ADDENDUM 03

Roseville Joint Union High School District
West Park High School, Phase 2 – Increment 1
DSA Application Number: 02-118062

DLR Group Project No: 75-19101-00

FP1.F3.1

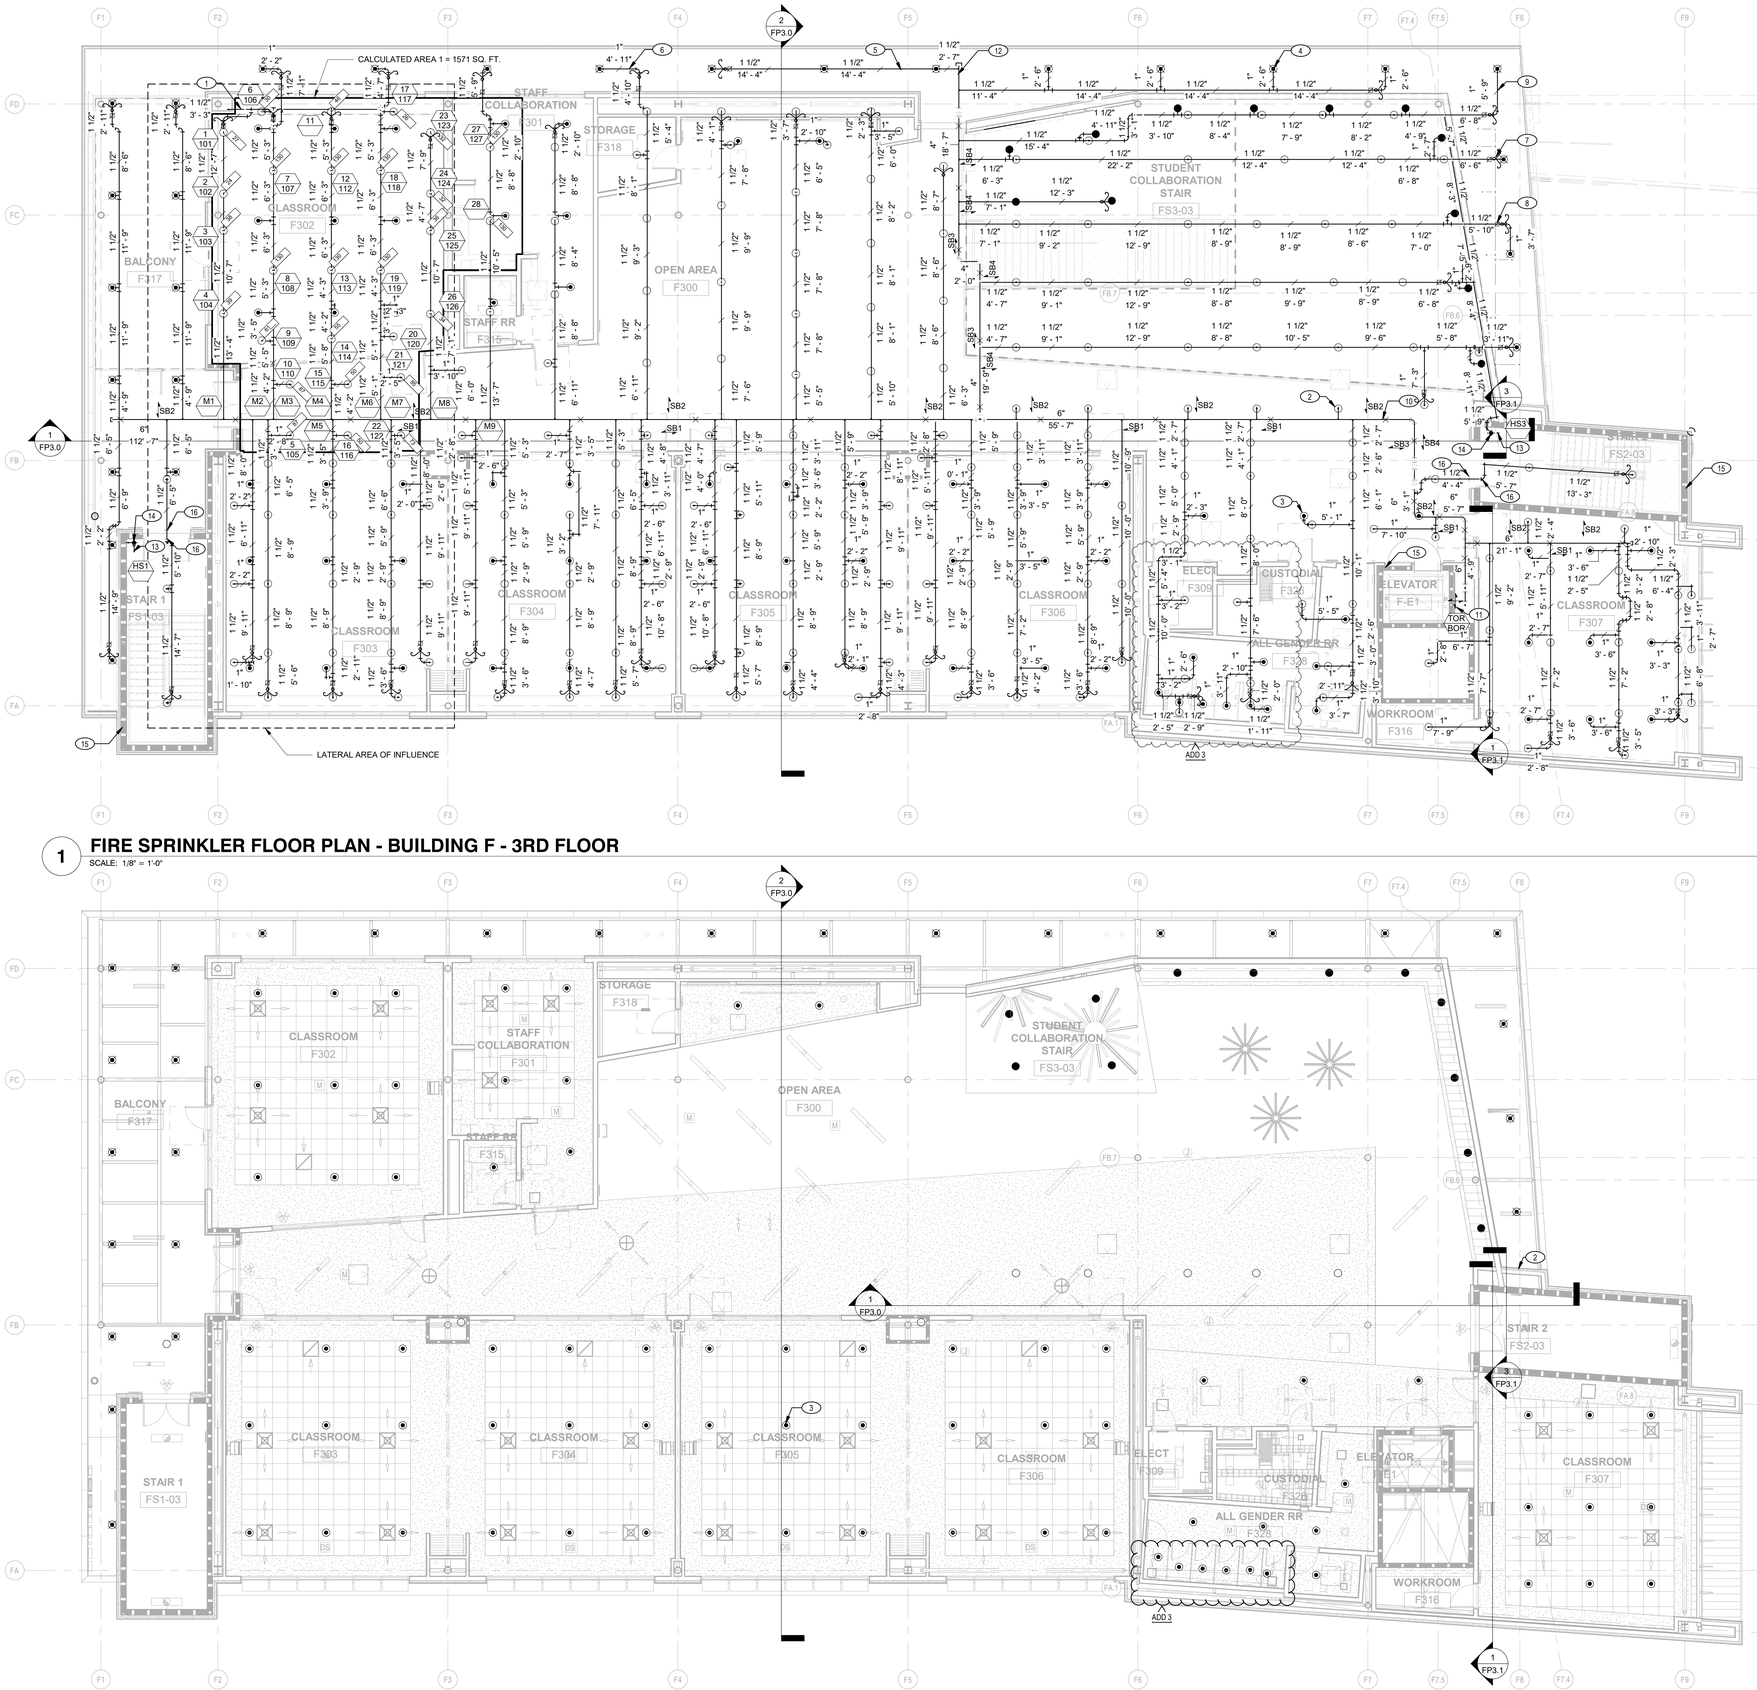
9. **Sheet FP1.F3.1 FIRE SPRINKLER – BLDG F – 3RD FLOOR**
   A. *REVISED piping at All-gender restroom*
   B. *ADDED sprinkler heads to each stall at All gender restroom*

FP1.S2.1

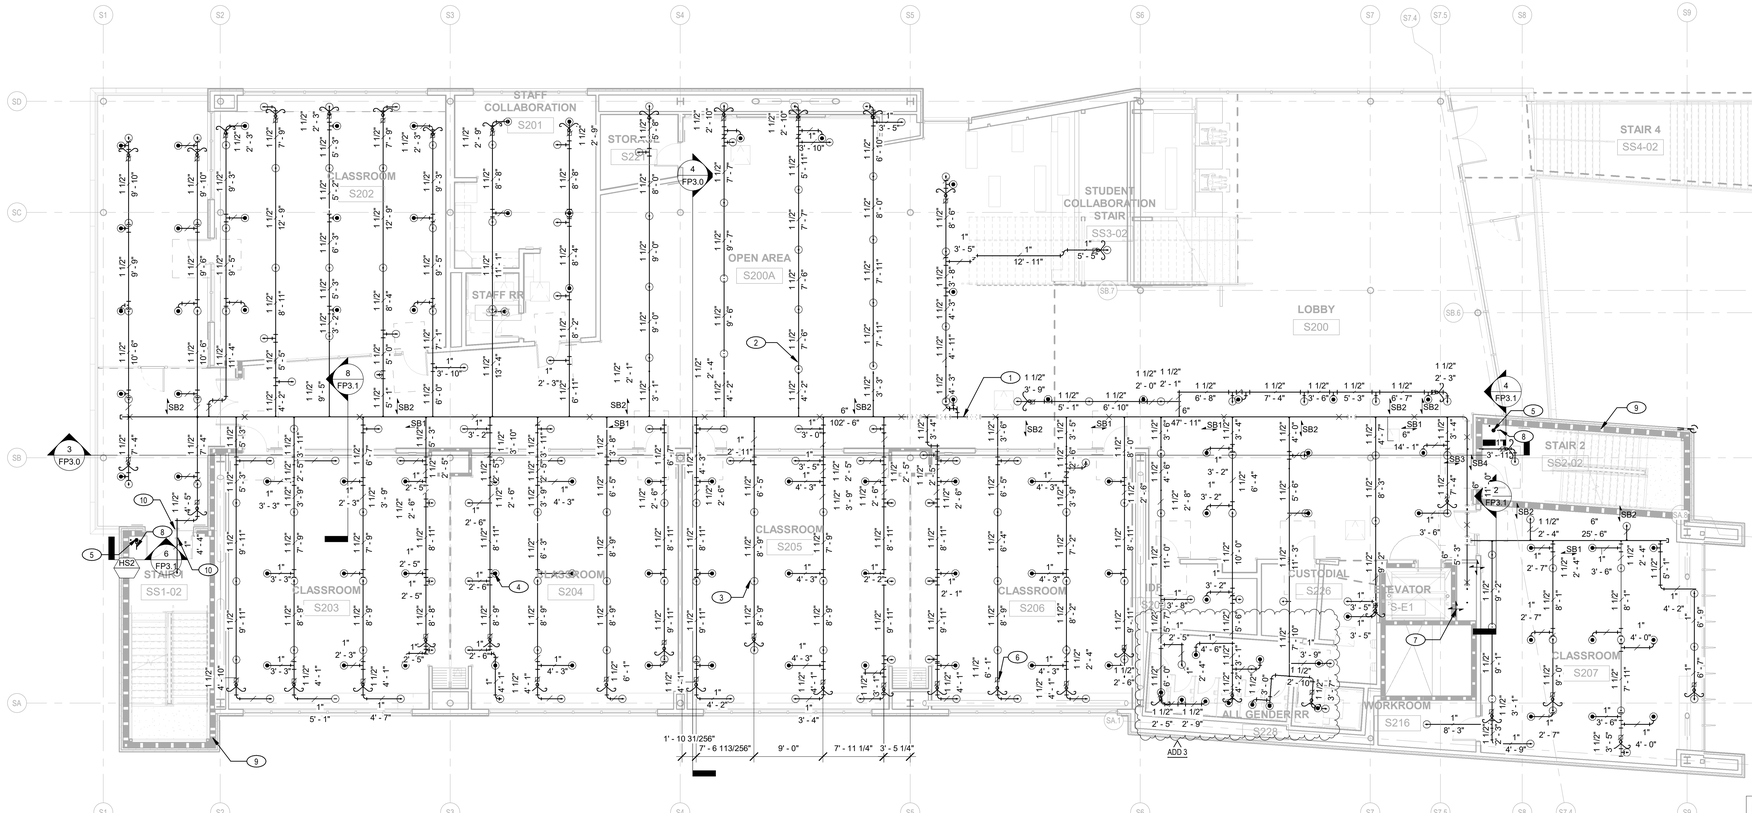
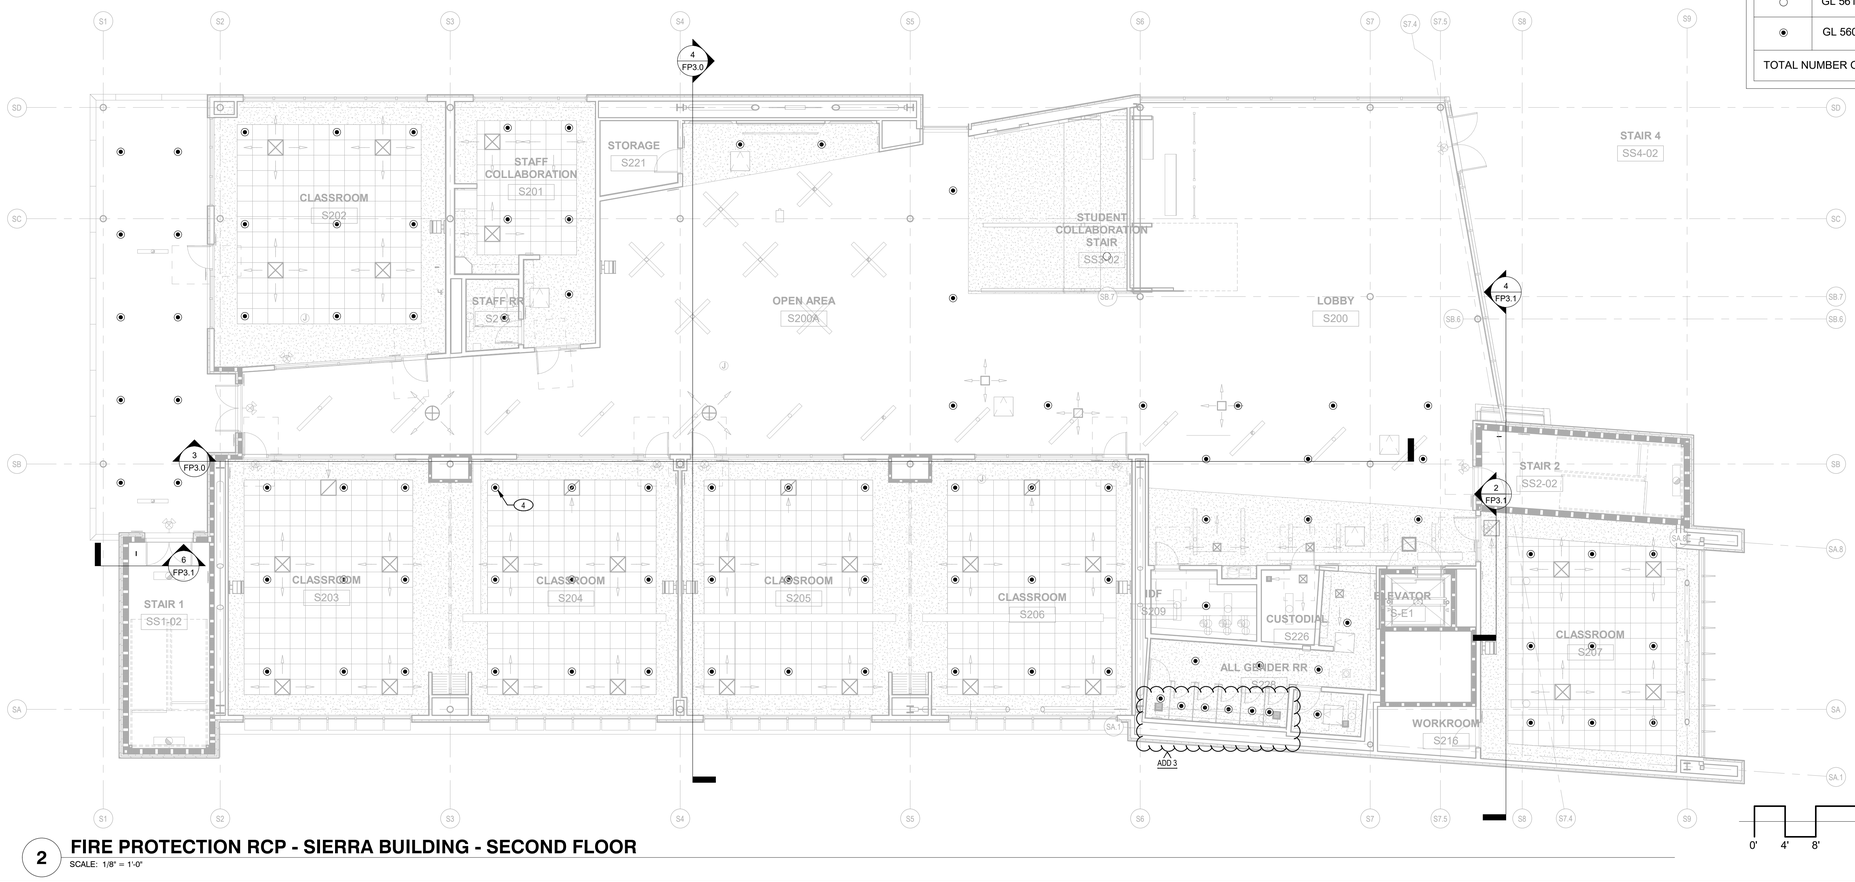
10. **Sheet FP1.S2.1 FIRE SPRINKLER – BLDG S – 2ND FLOOR**
   A. *REVISED piping at All-gender restroom*
   B. *ADDED sprinkler heads to each stall at All gender restroom*

1 FIRE SPRINKLER FLOOR PLAN - BUILDING S - 3RD FLOOR

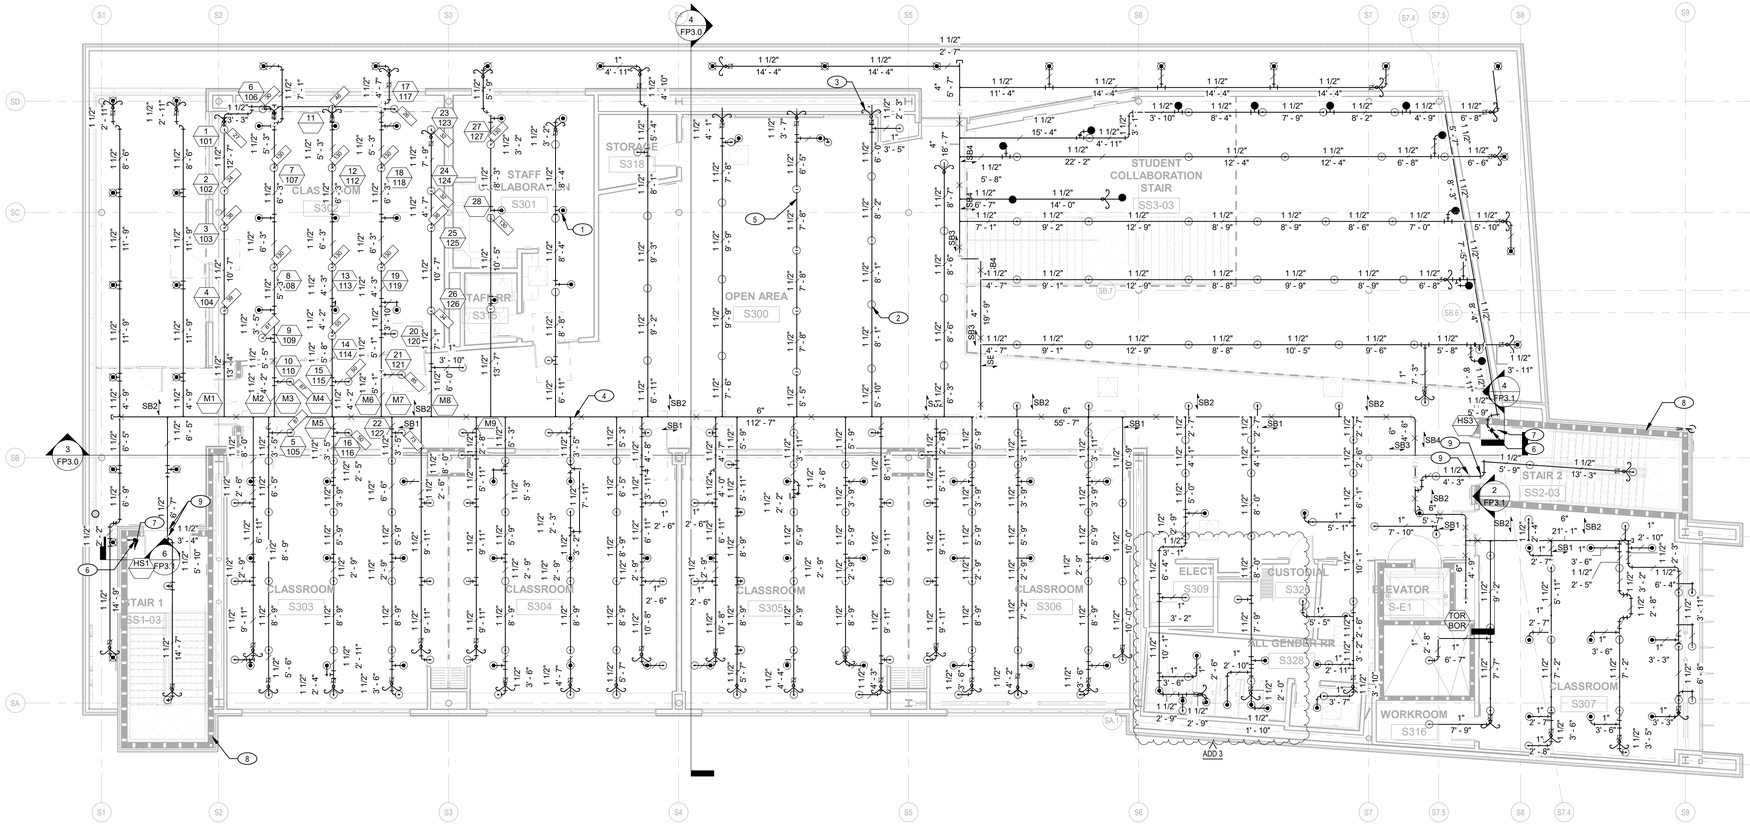
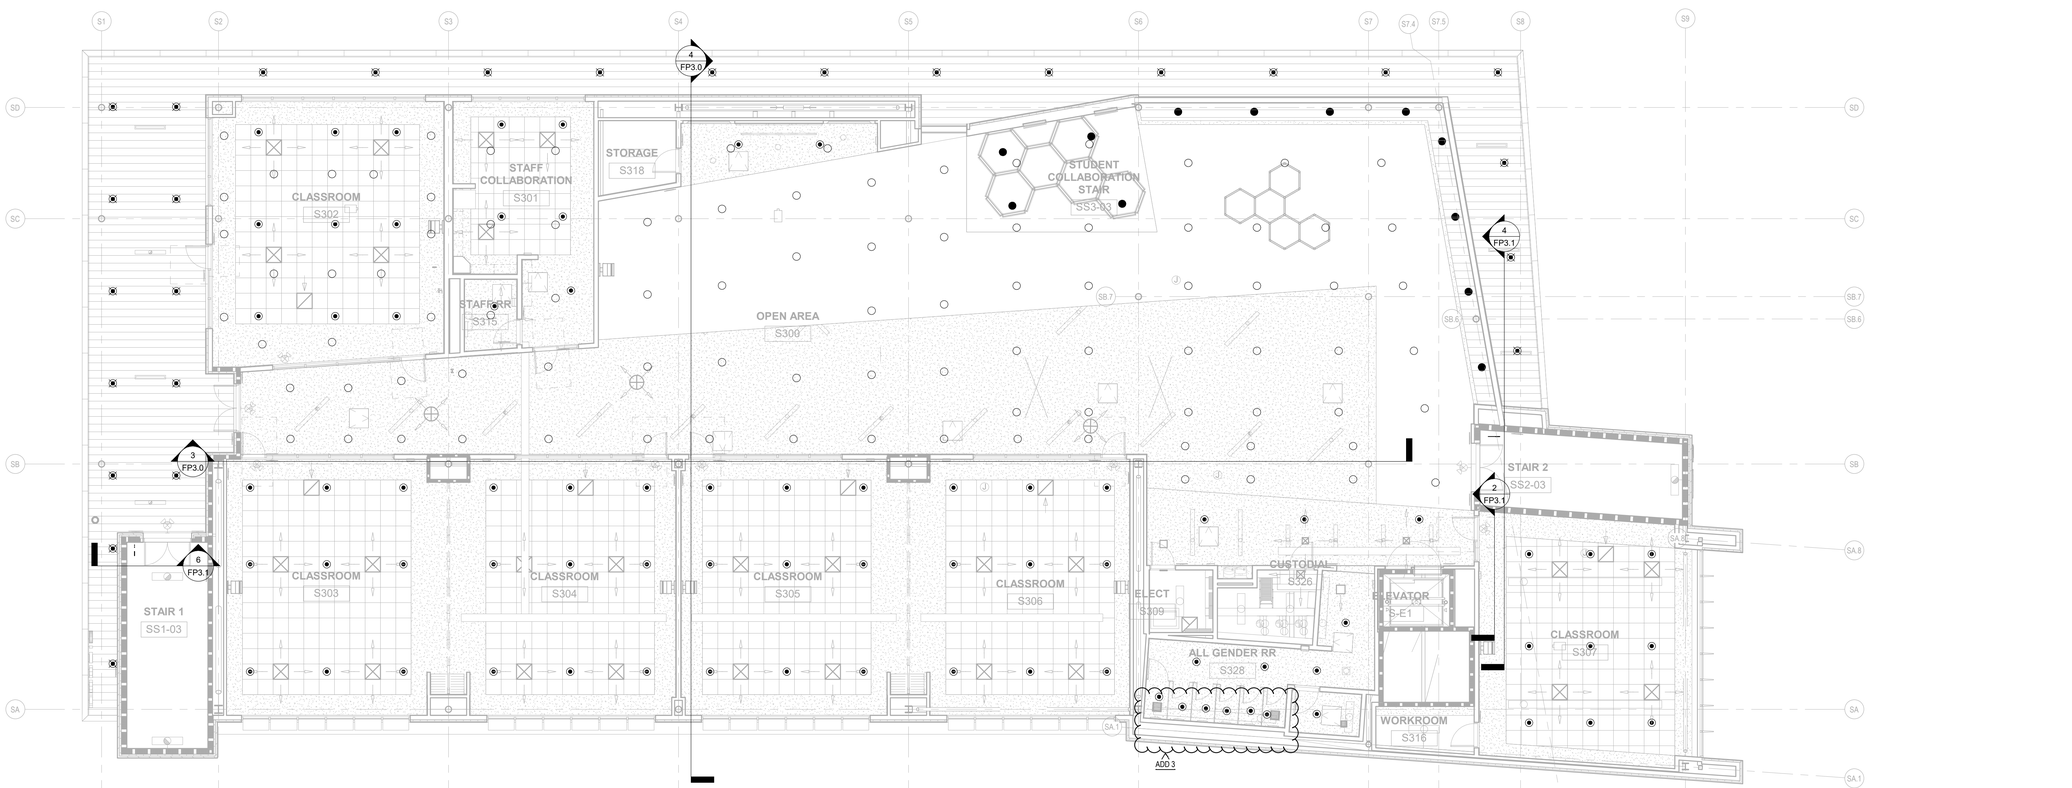
11. **Sheet FP1.S3.1 FIRE SPRINKLER – BLDG S – 3RD FLOOR**
   A. *REVISED piping at All-gender restroom*
   B. *ADDED sprinkler heads to each stall at All gender restroom*
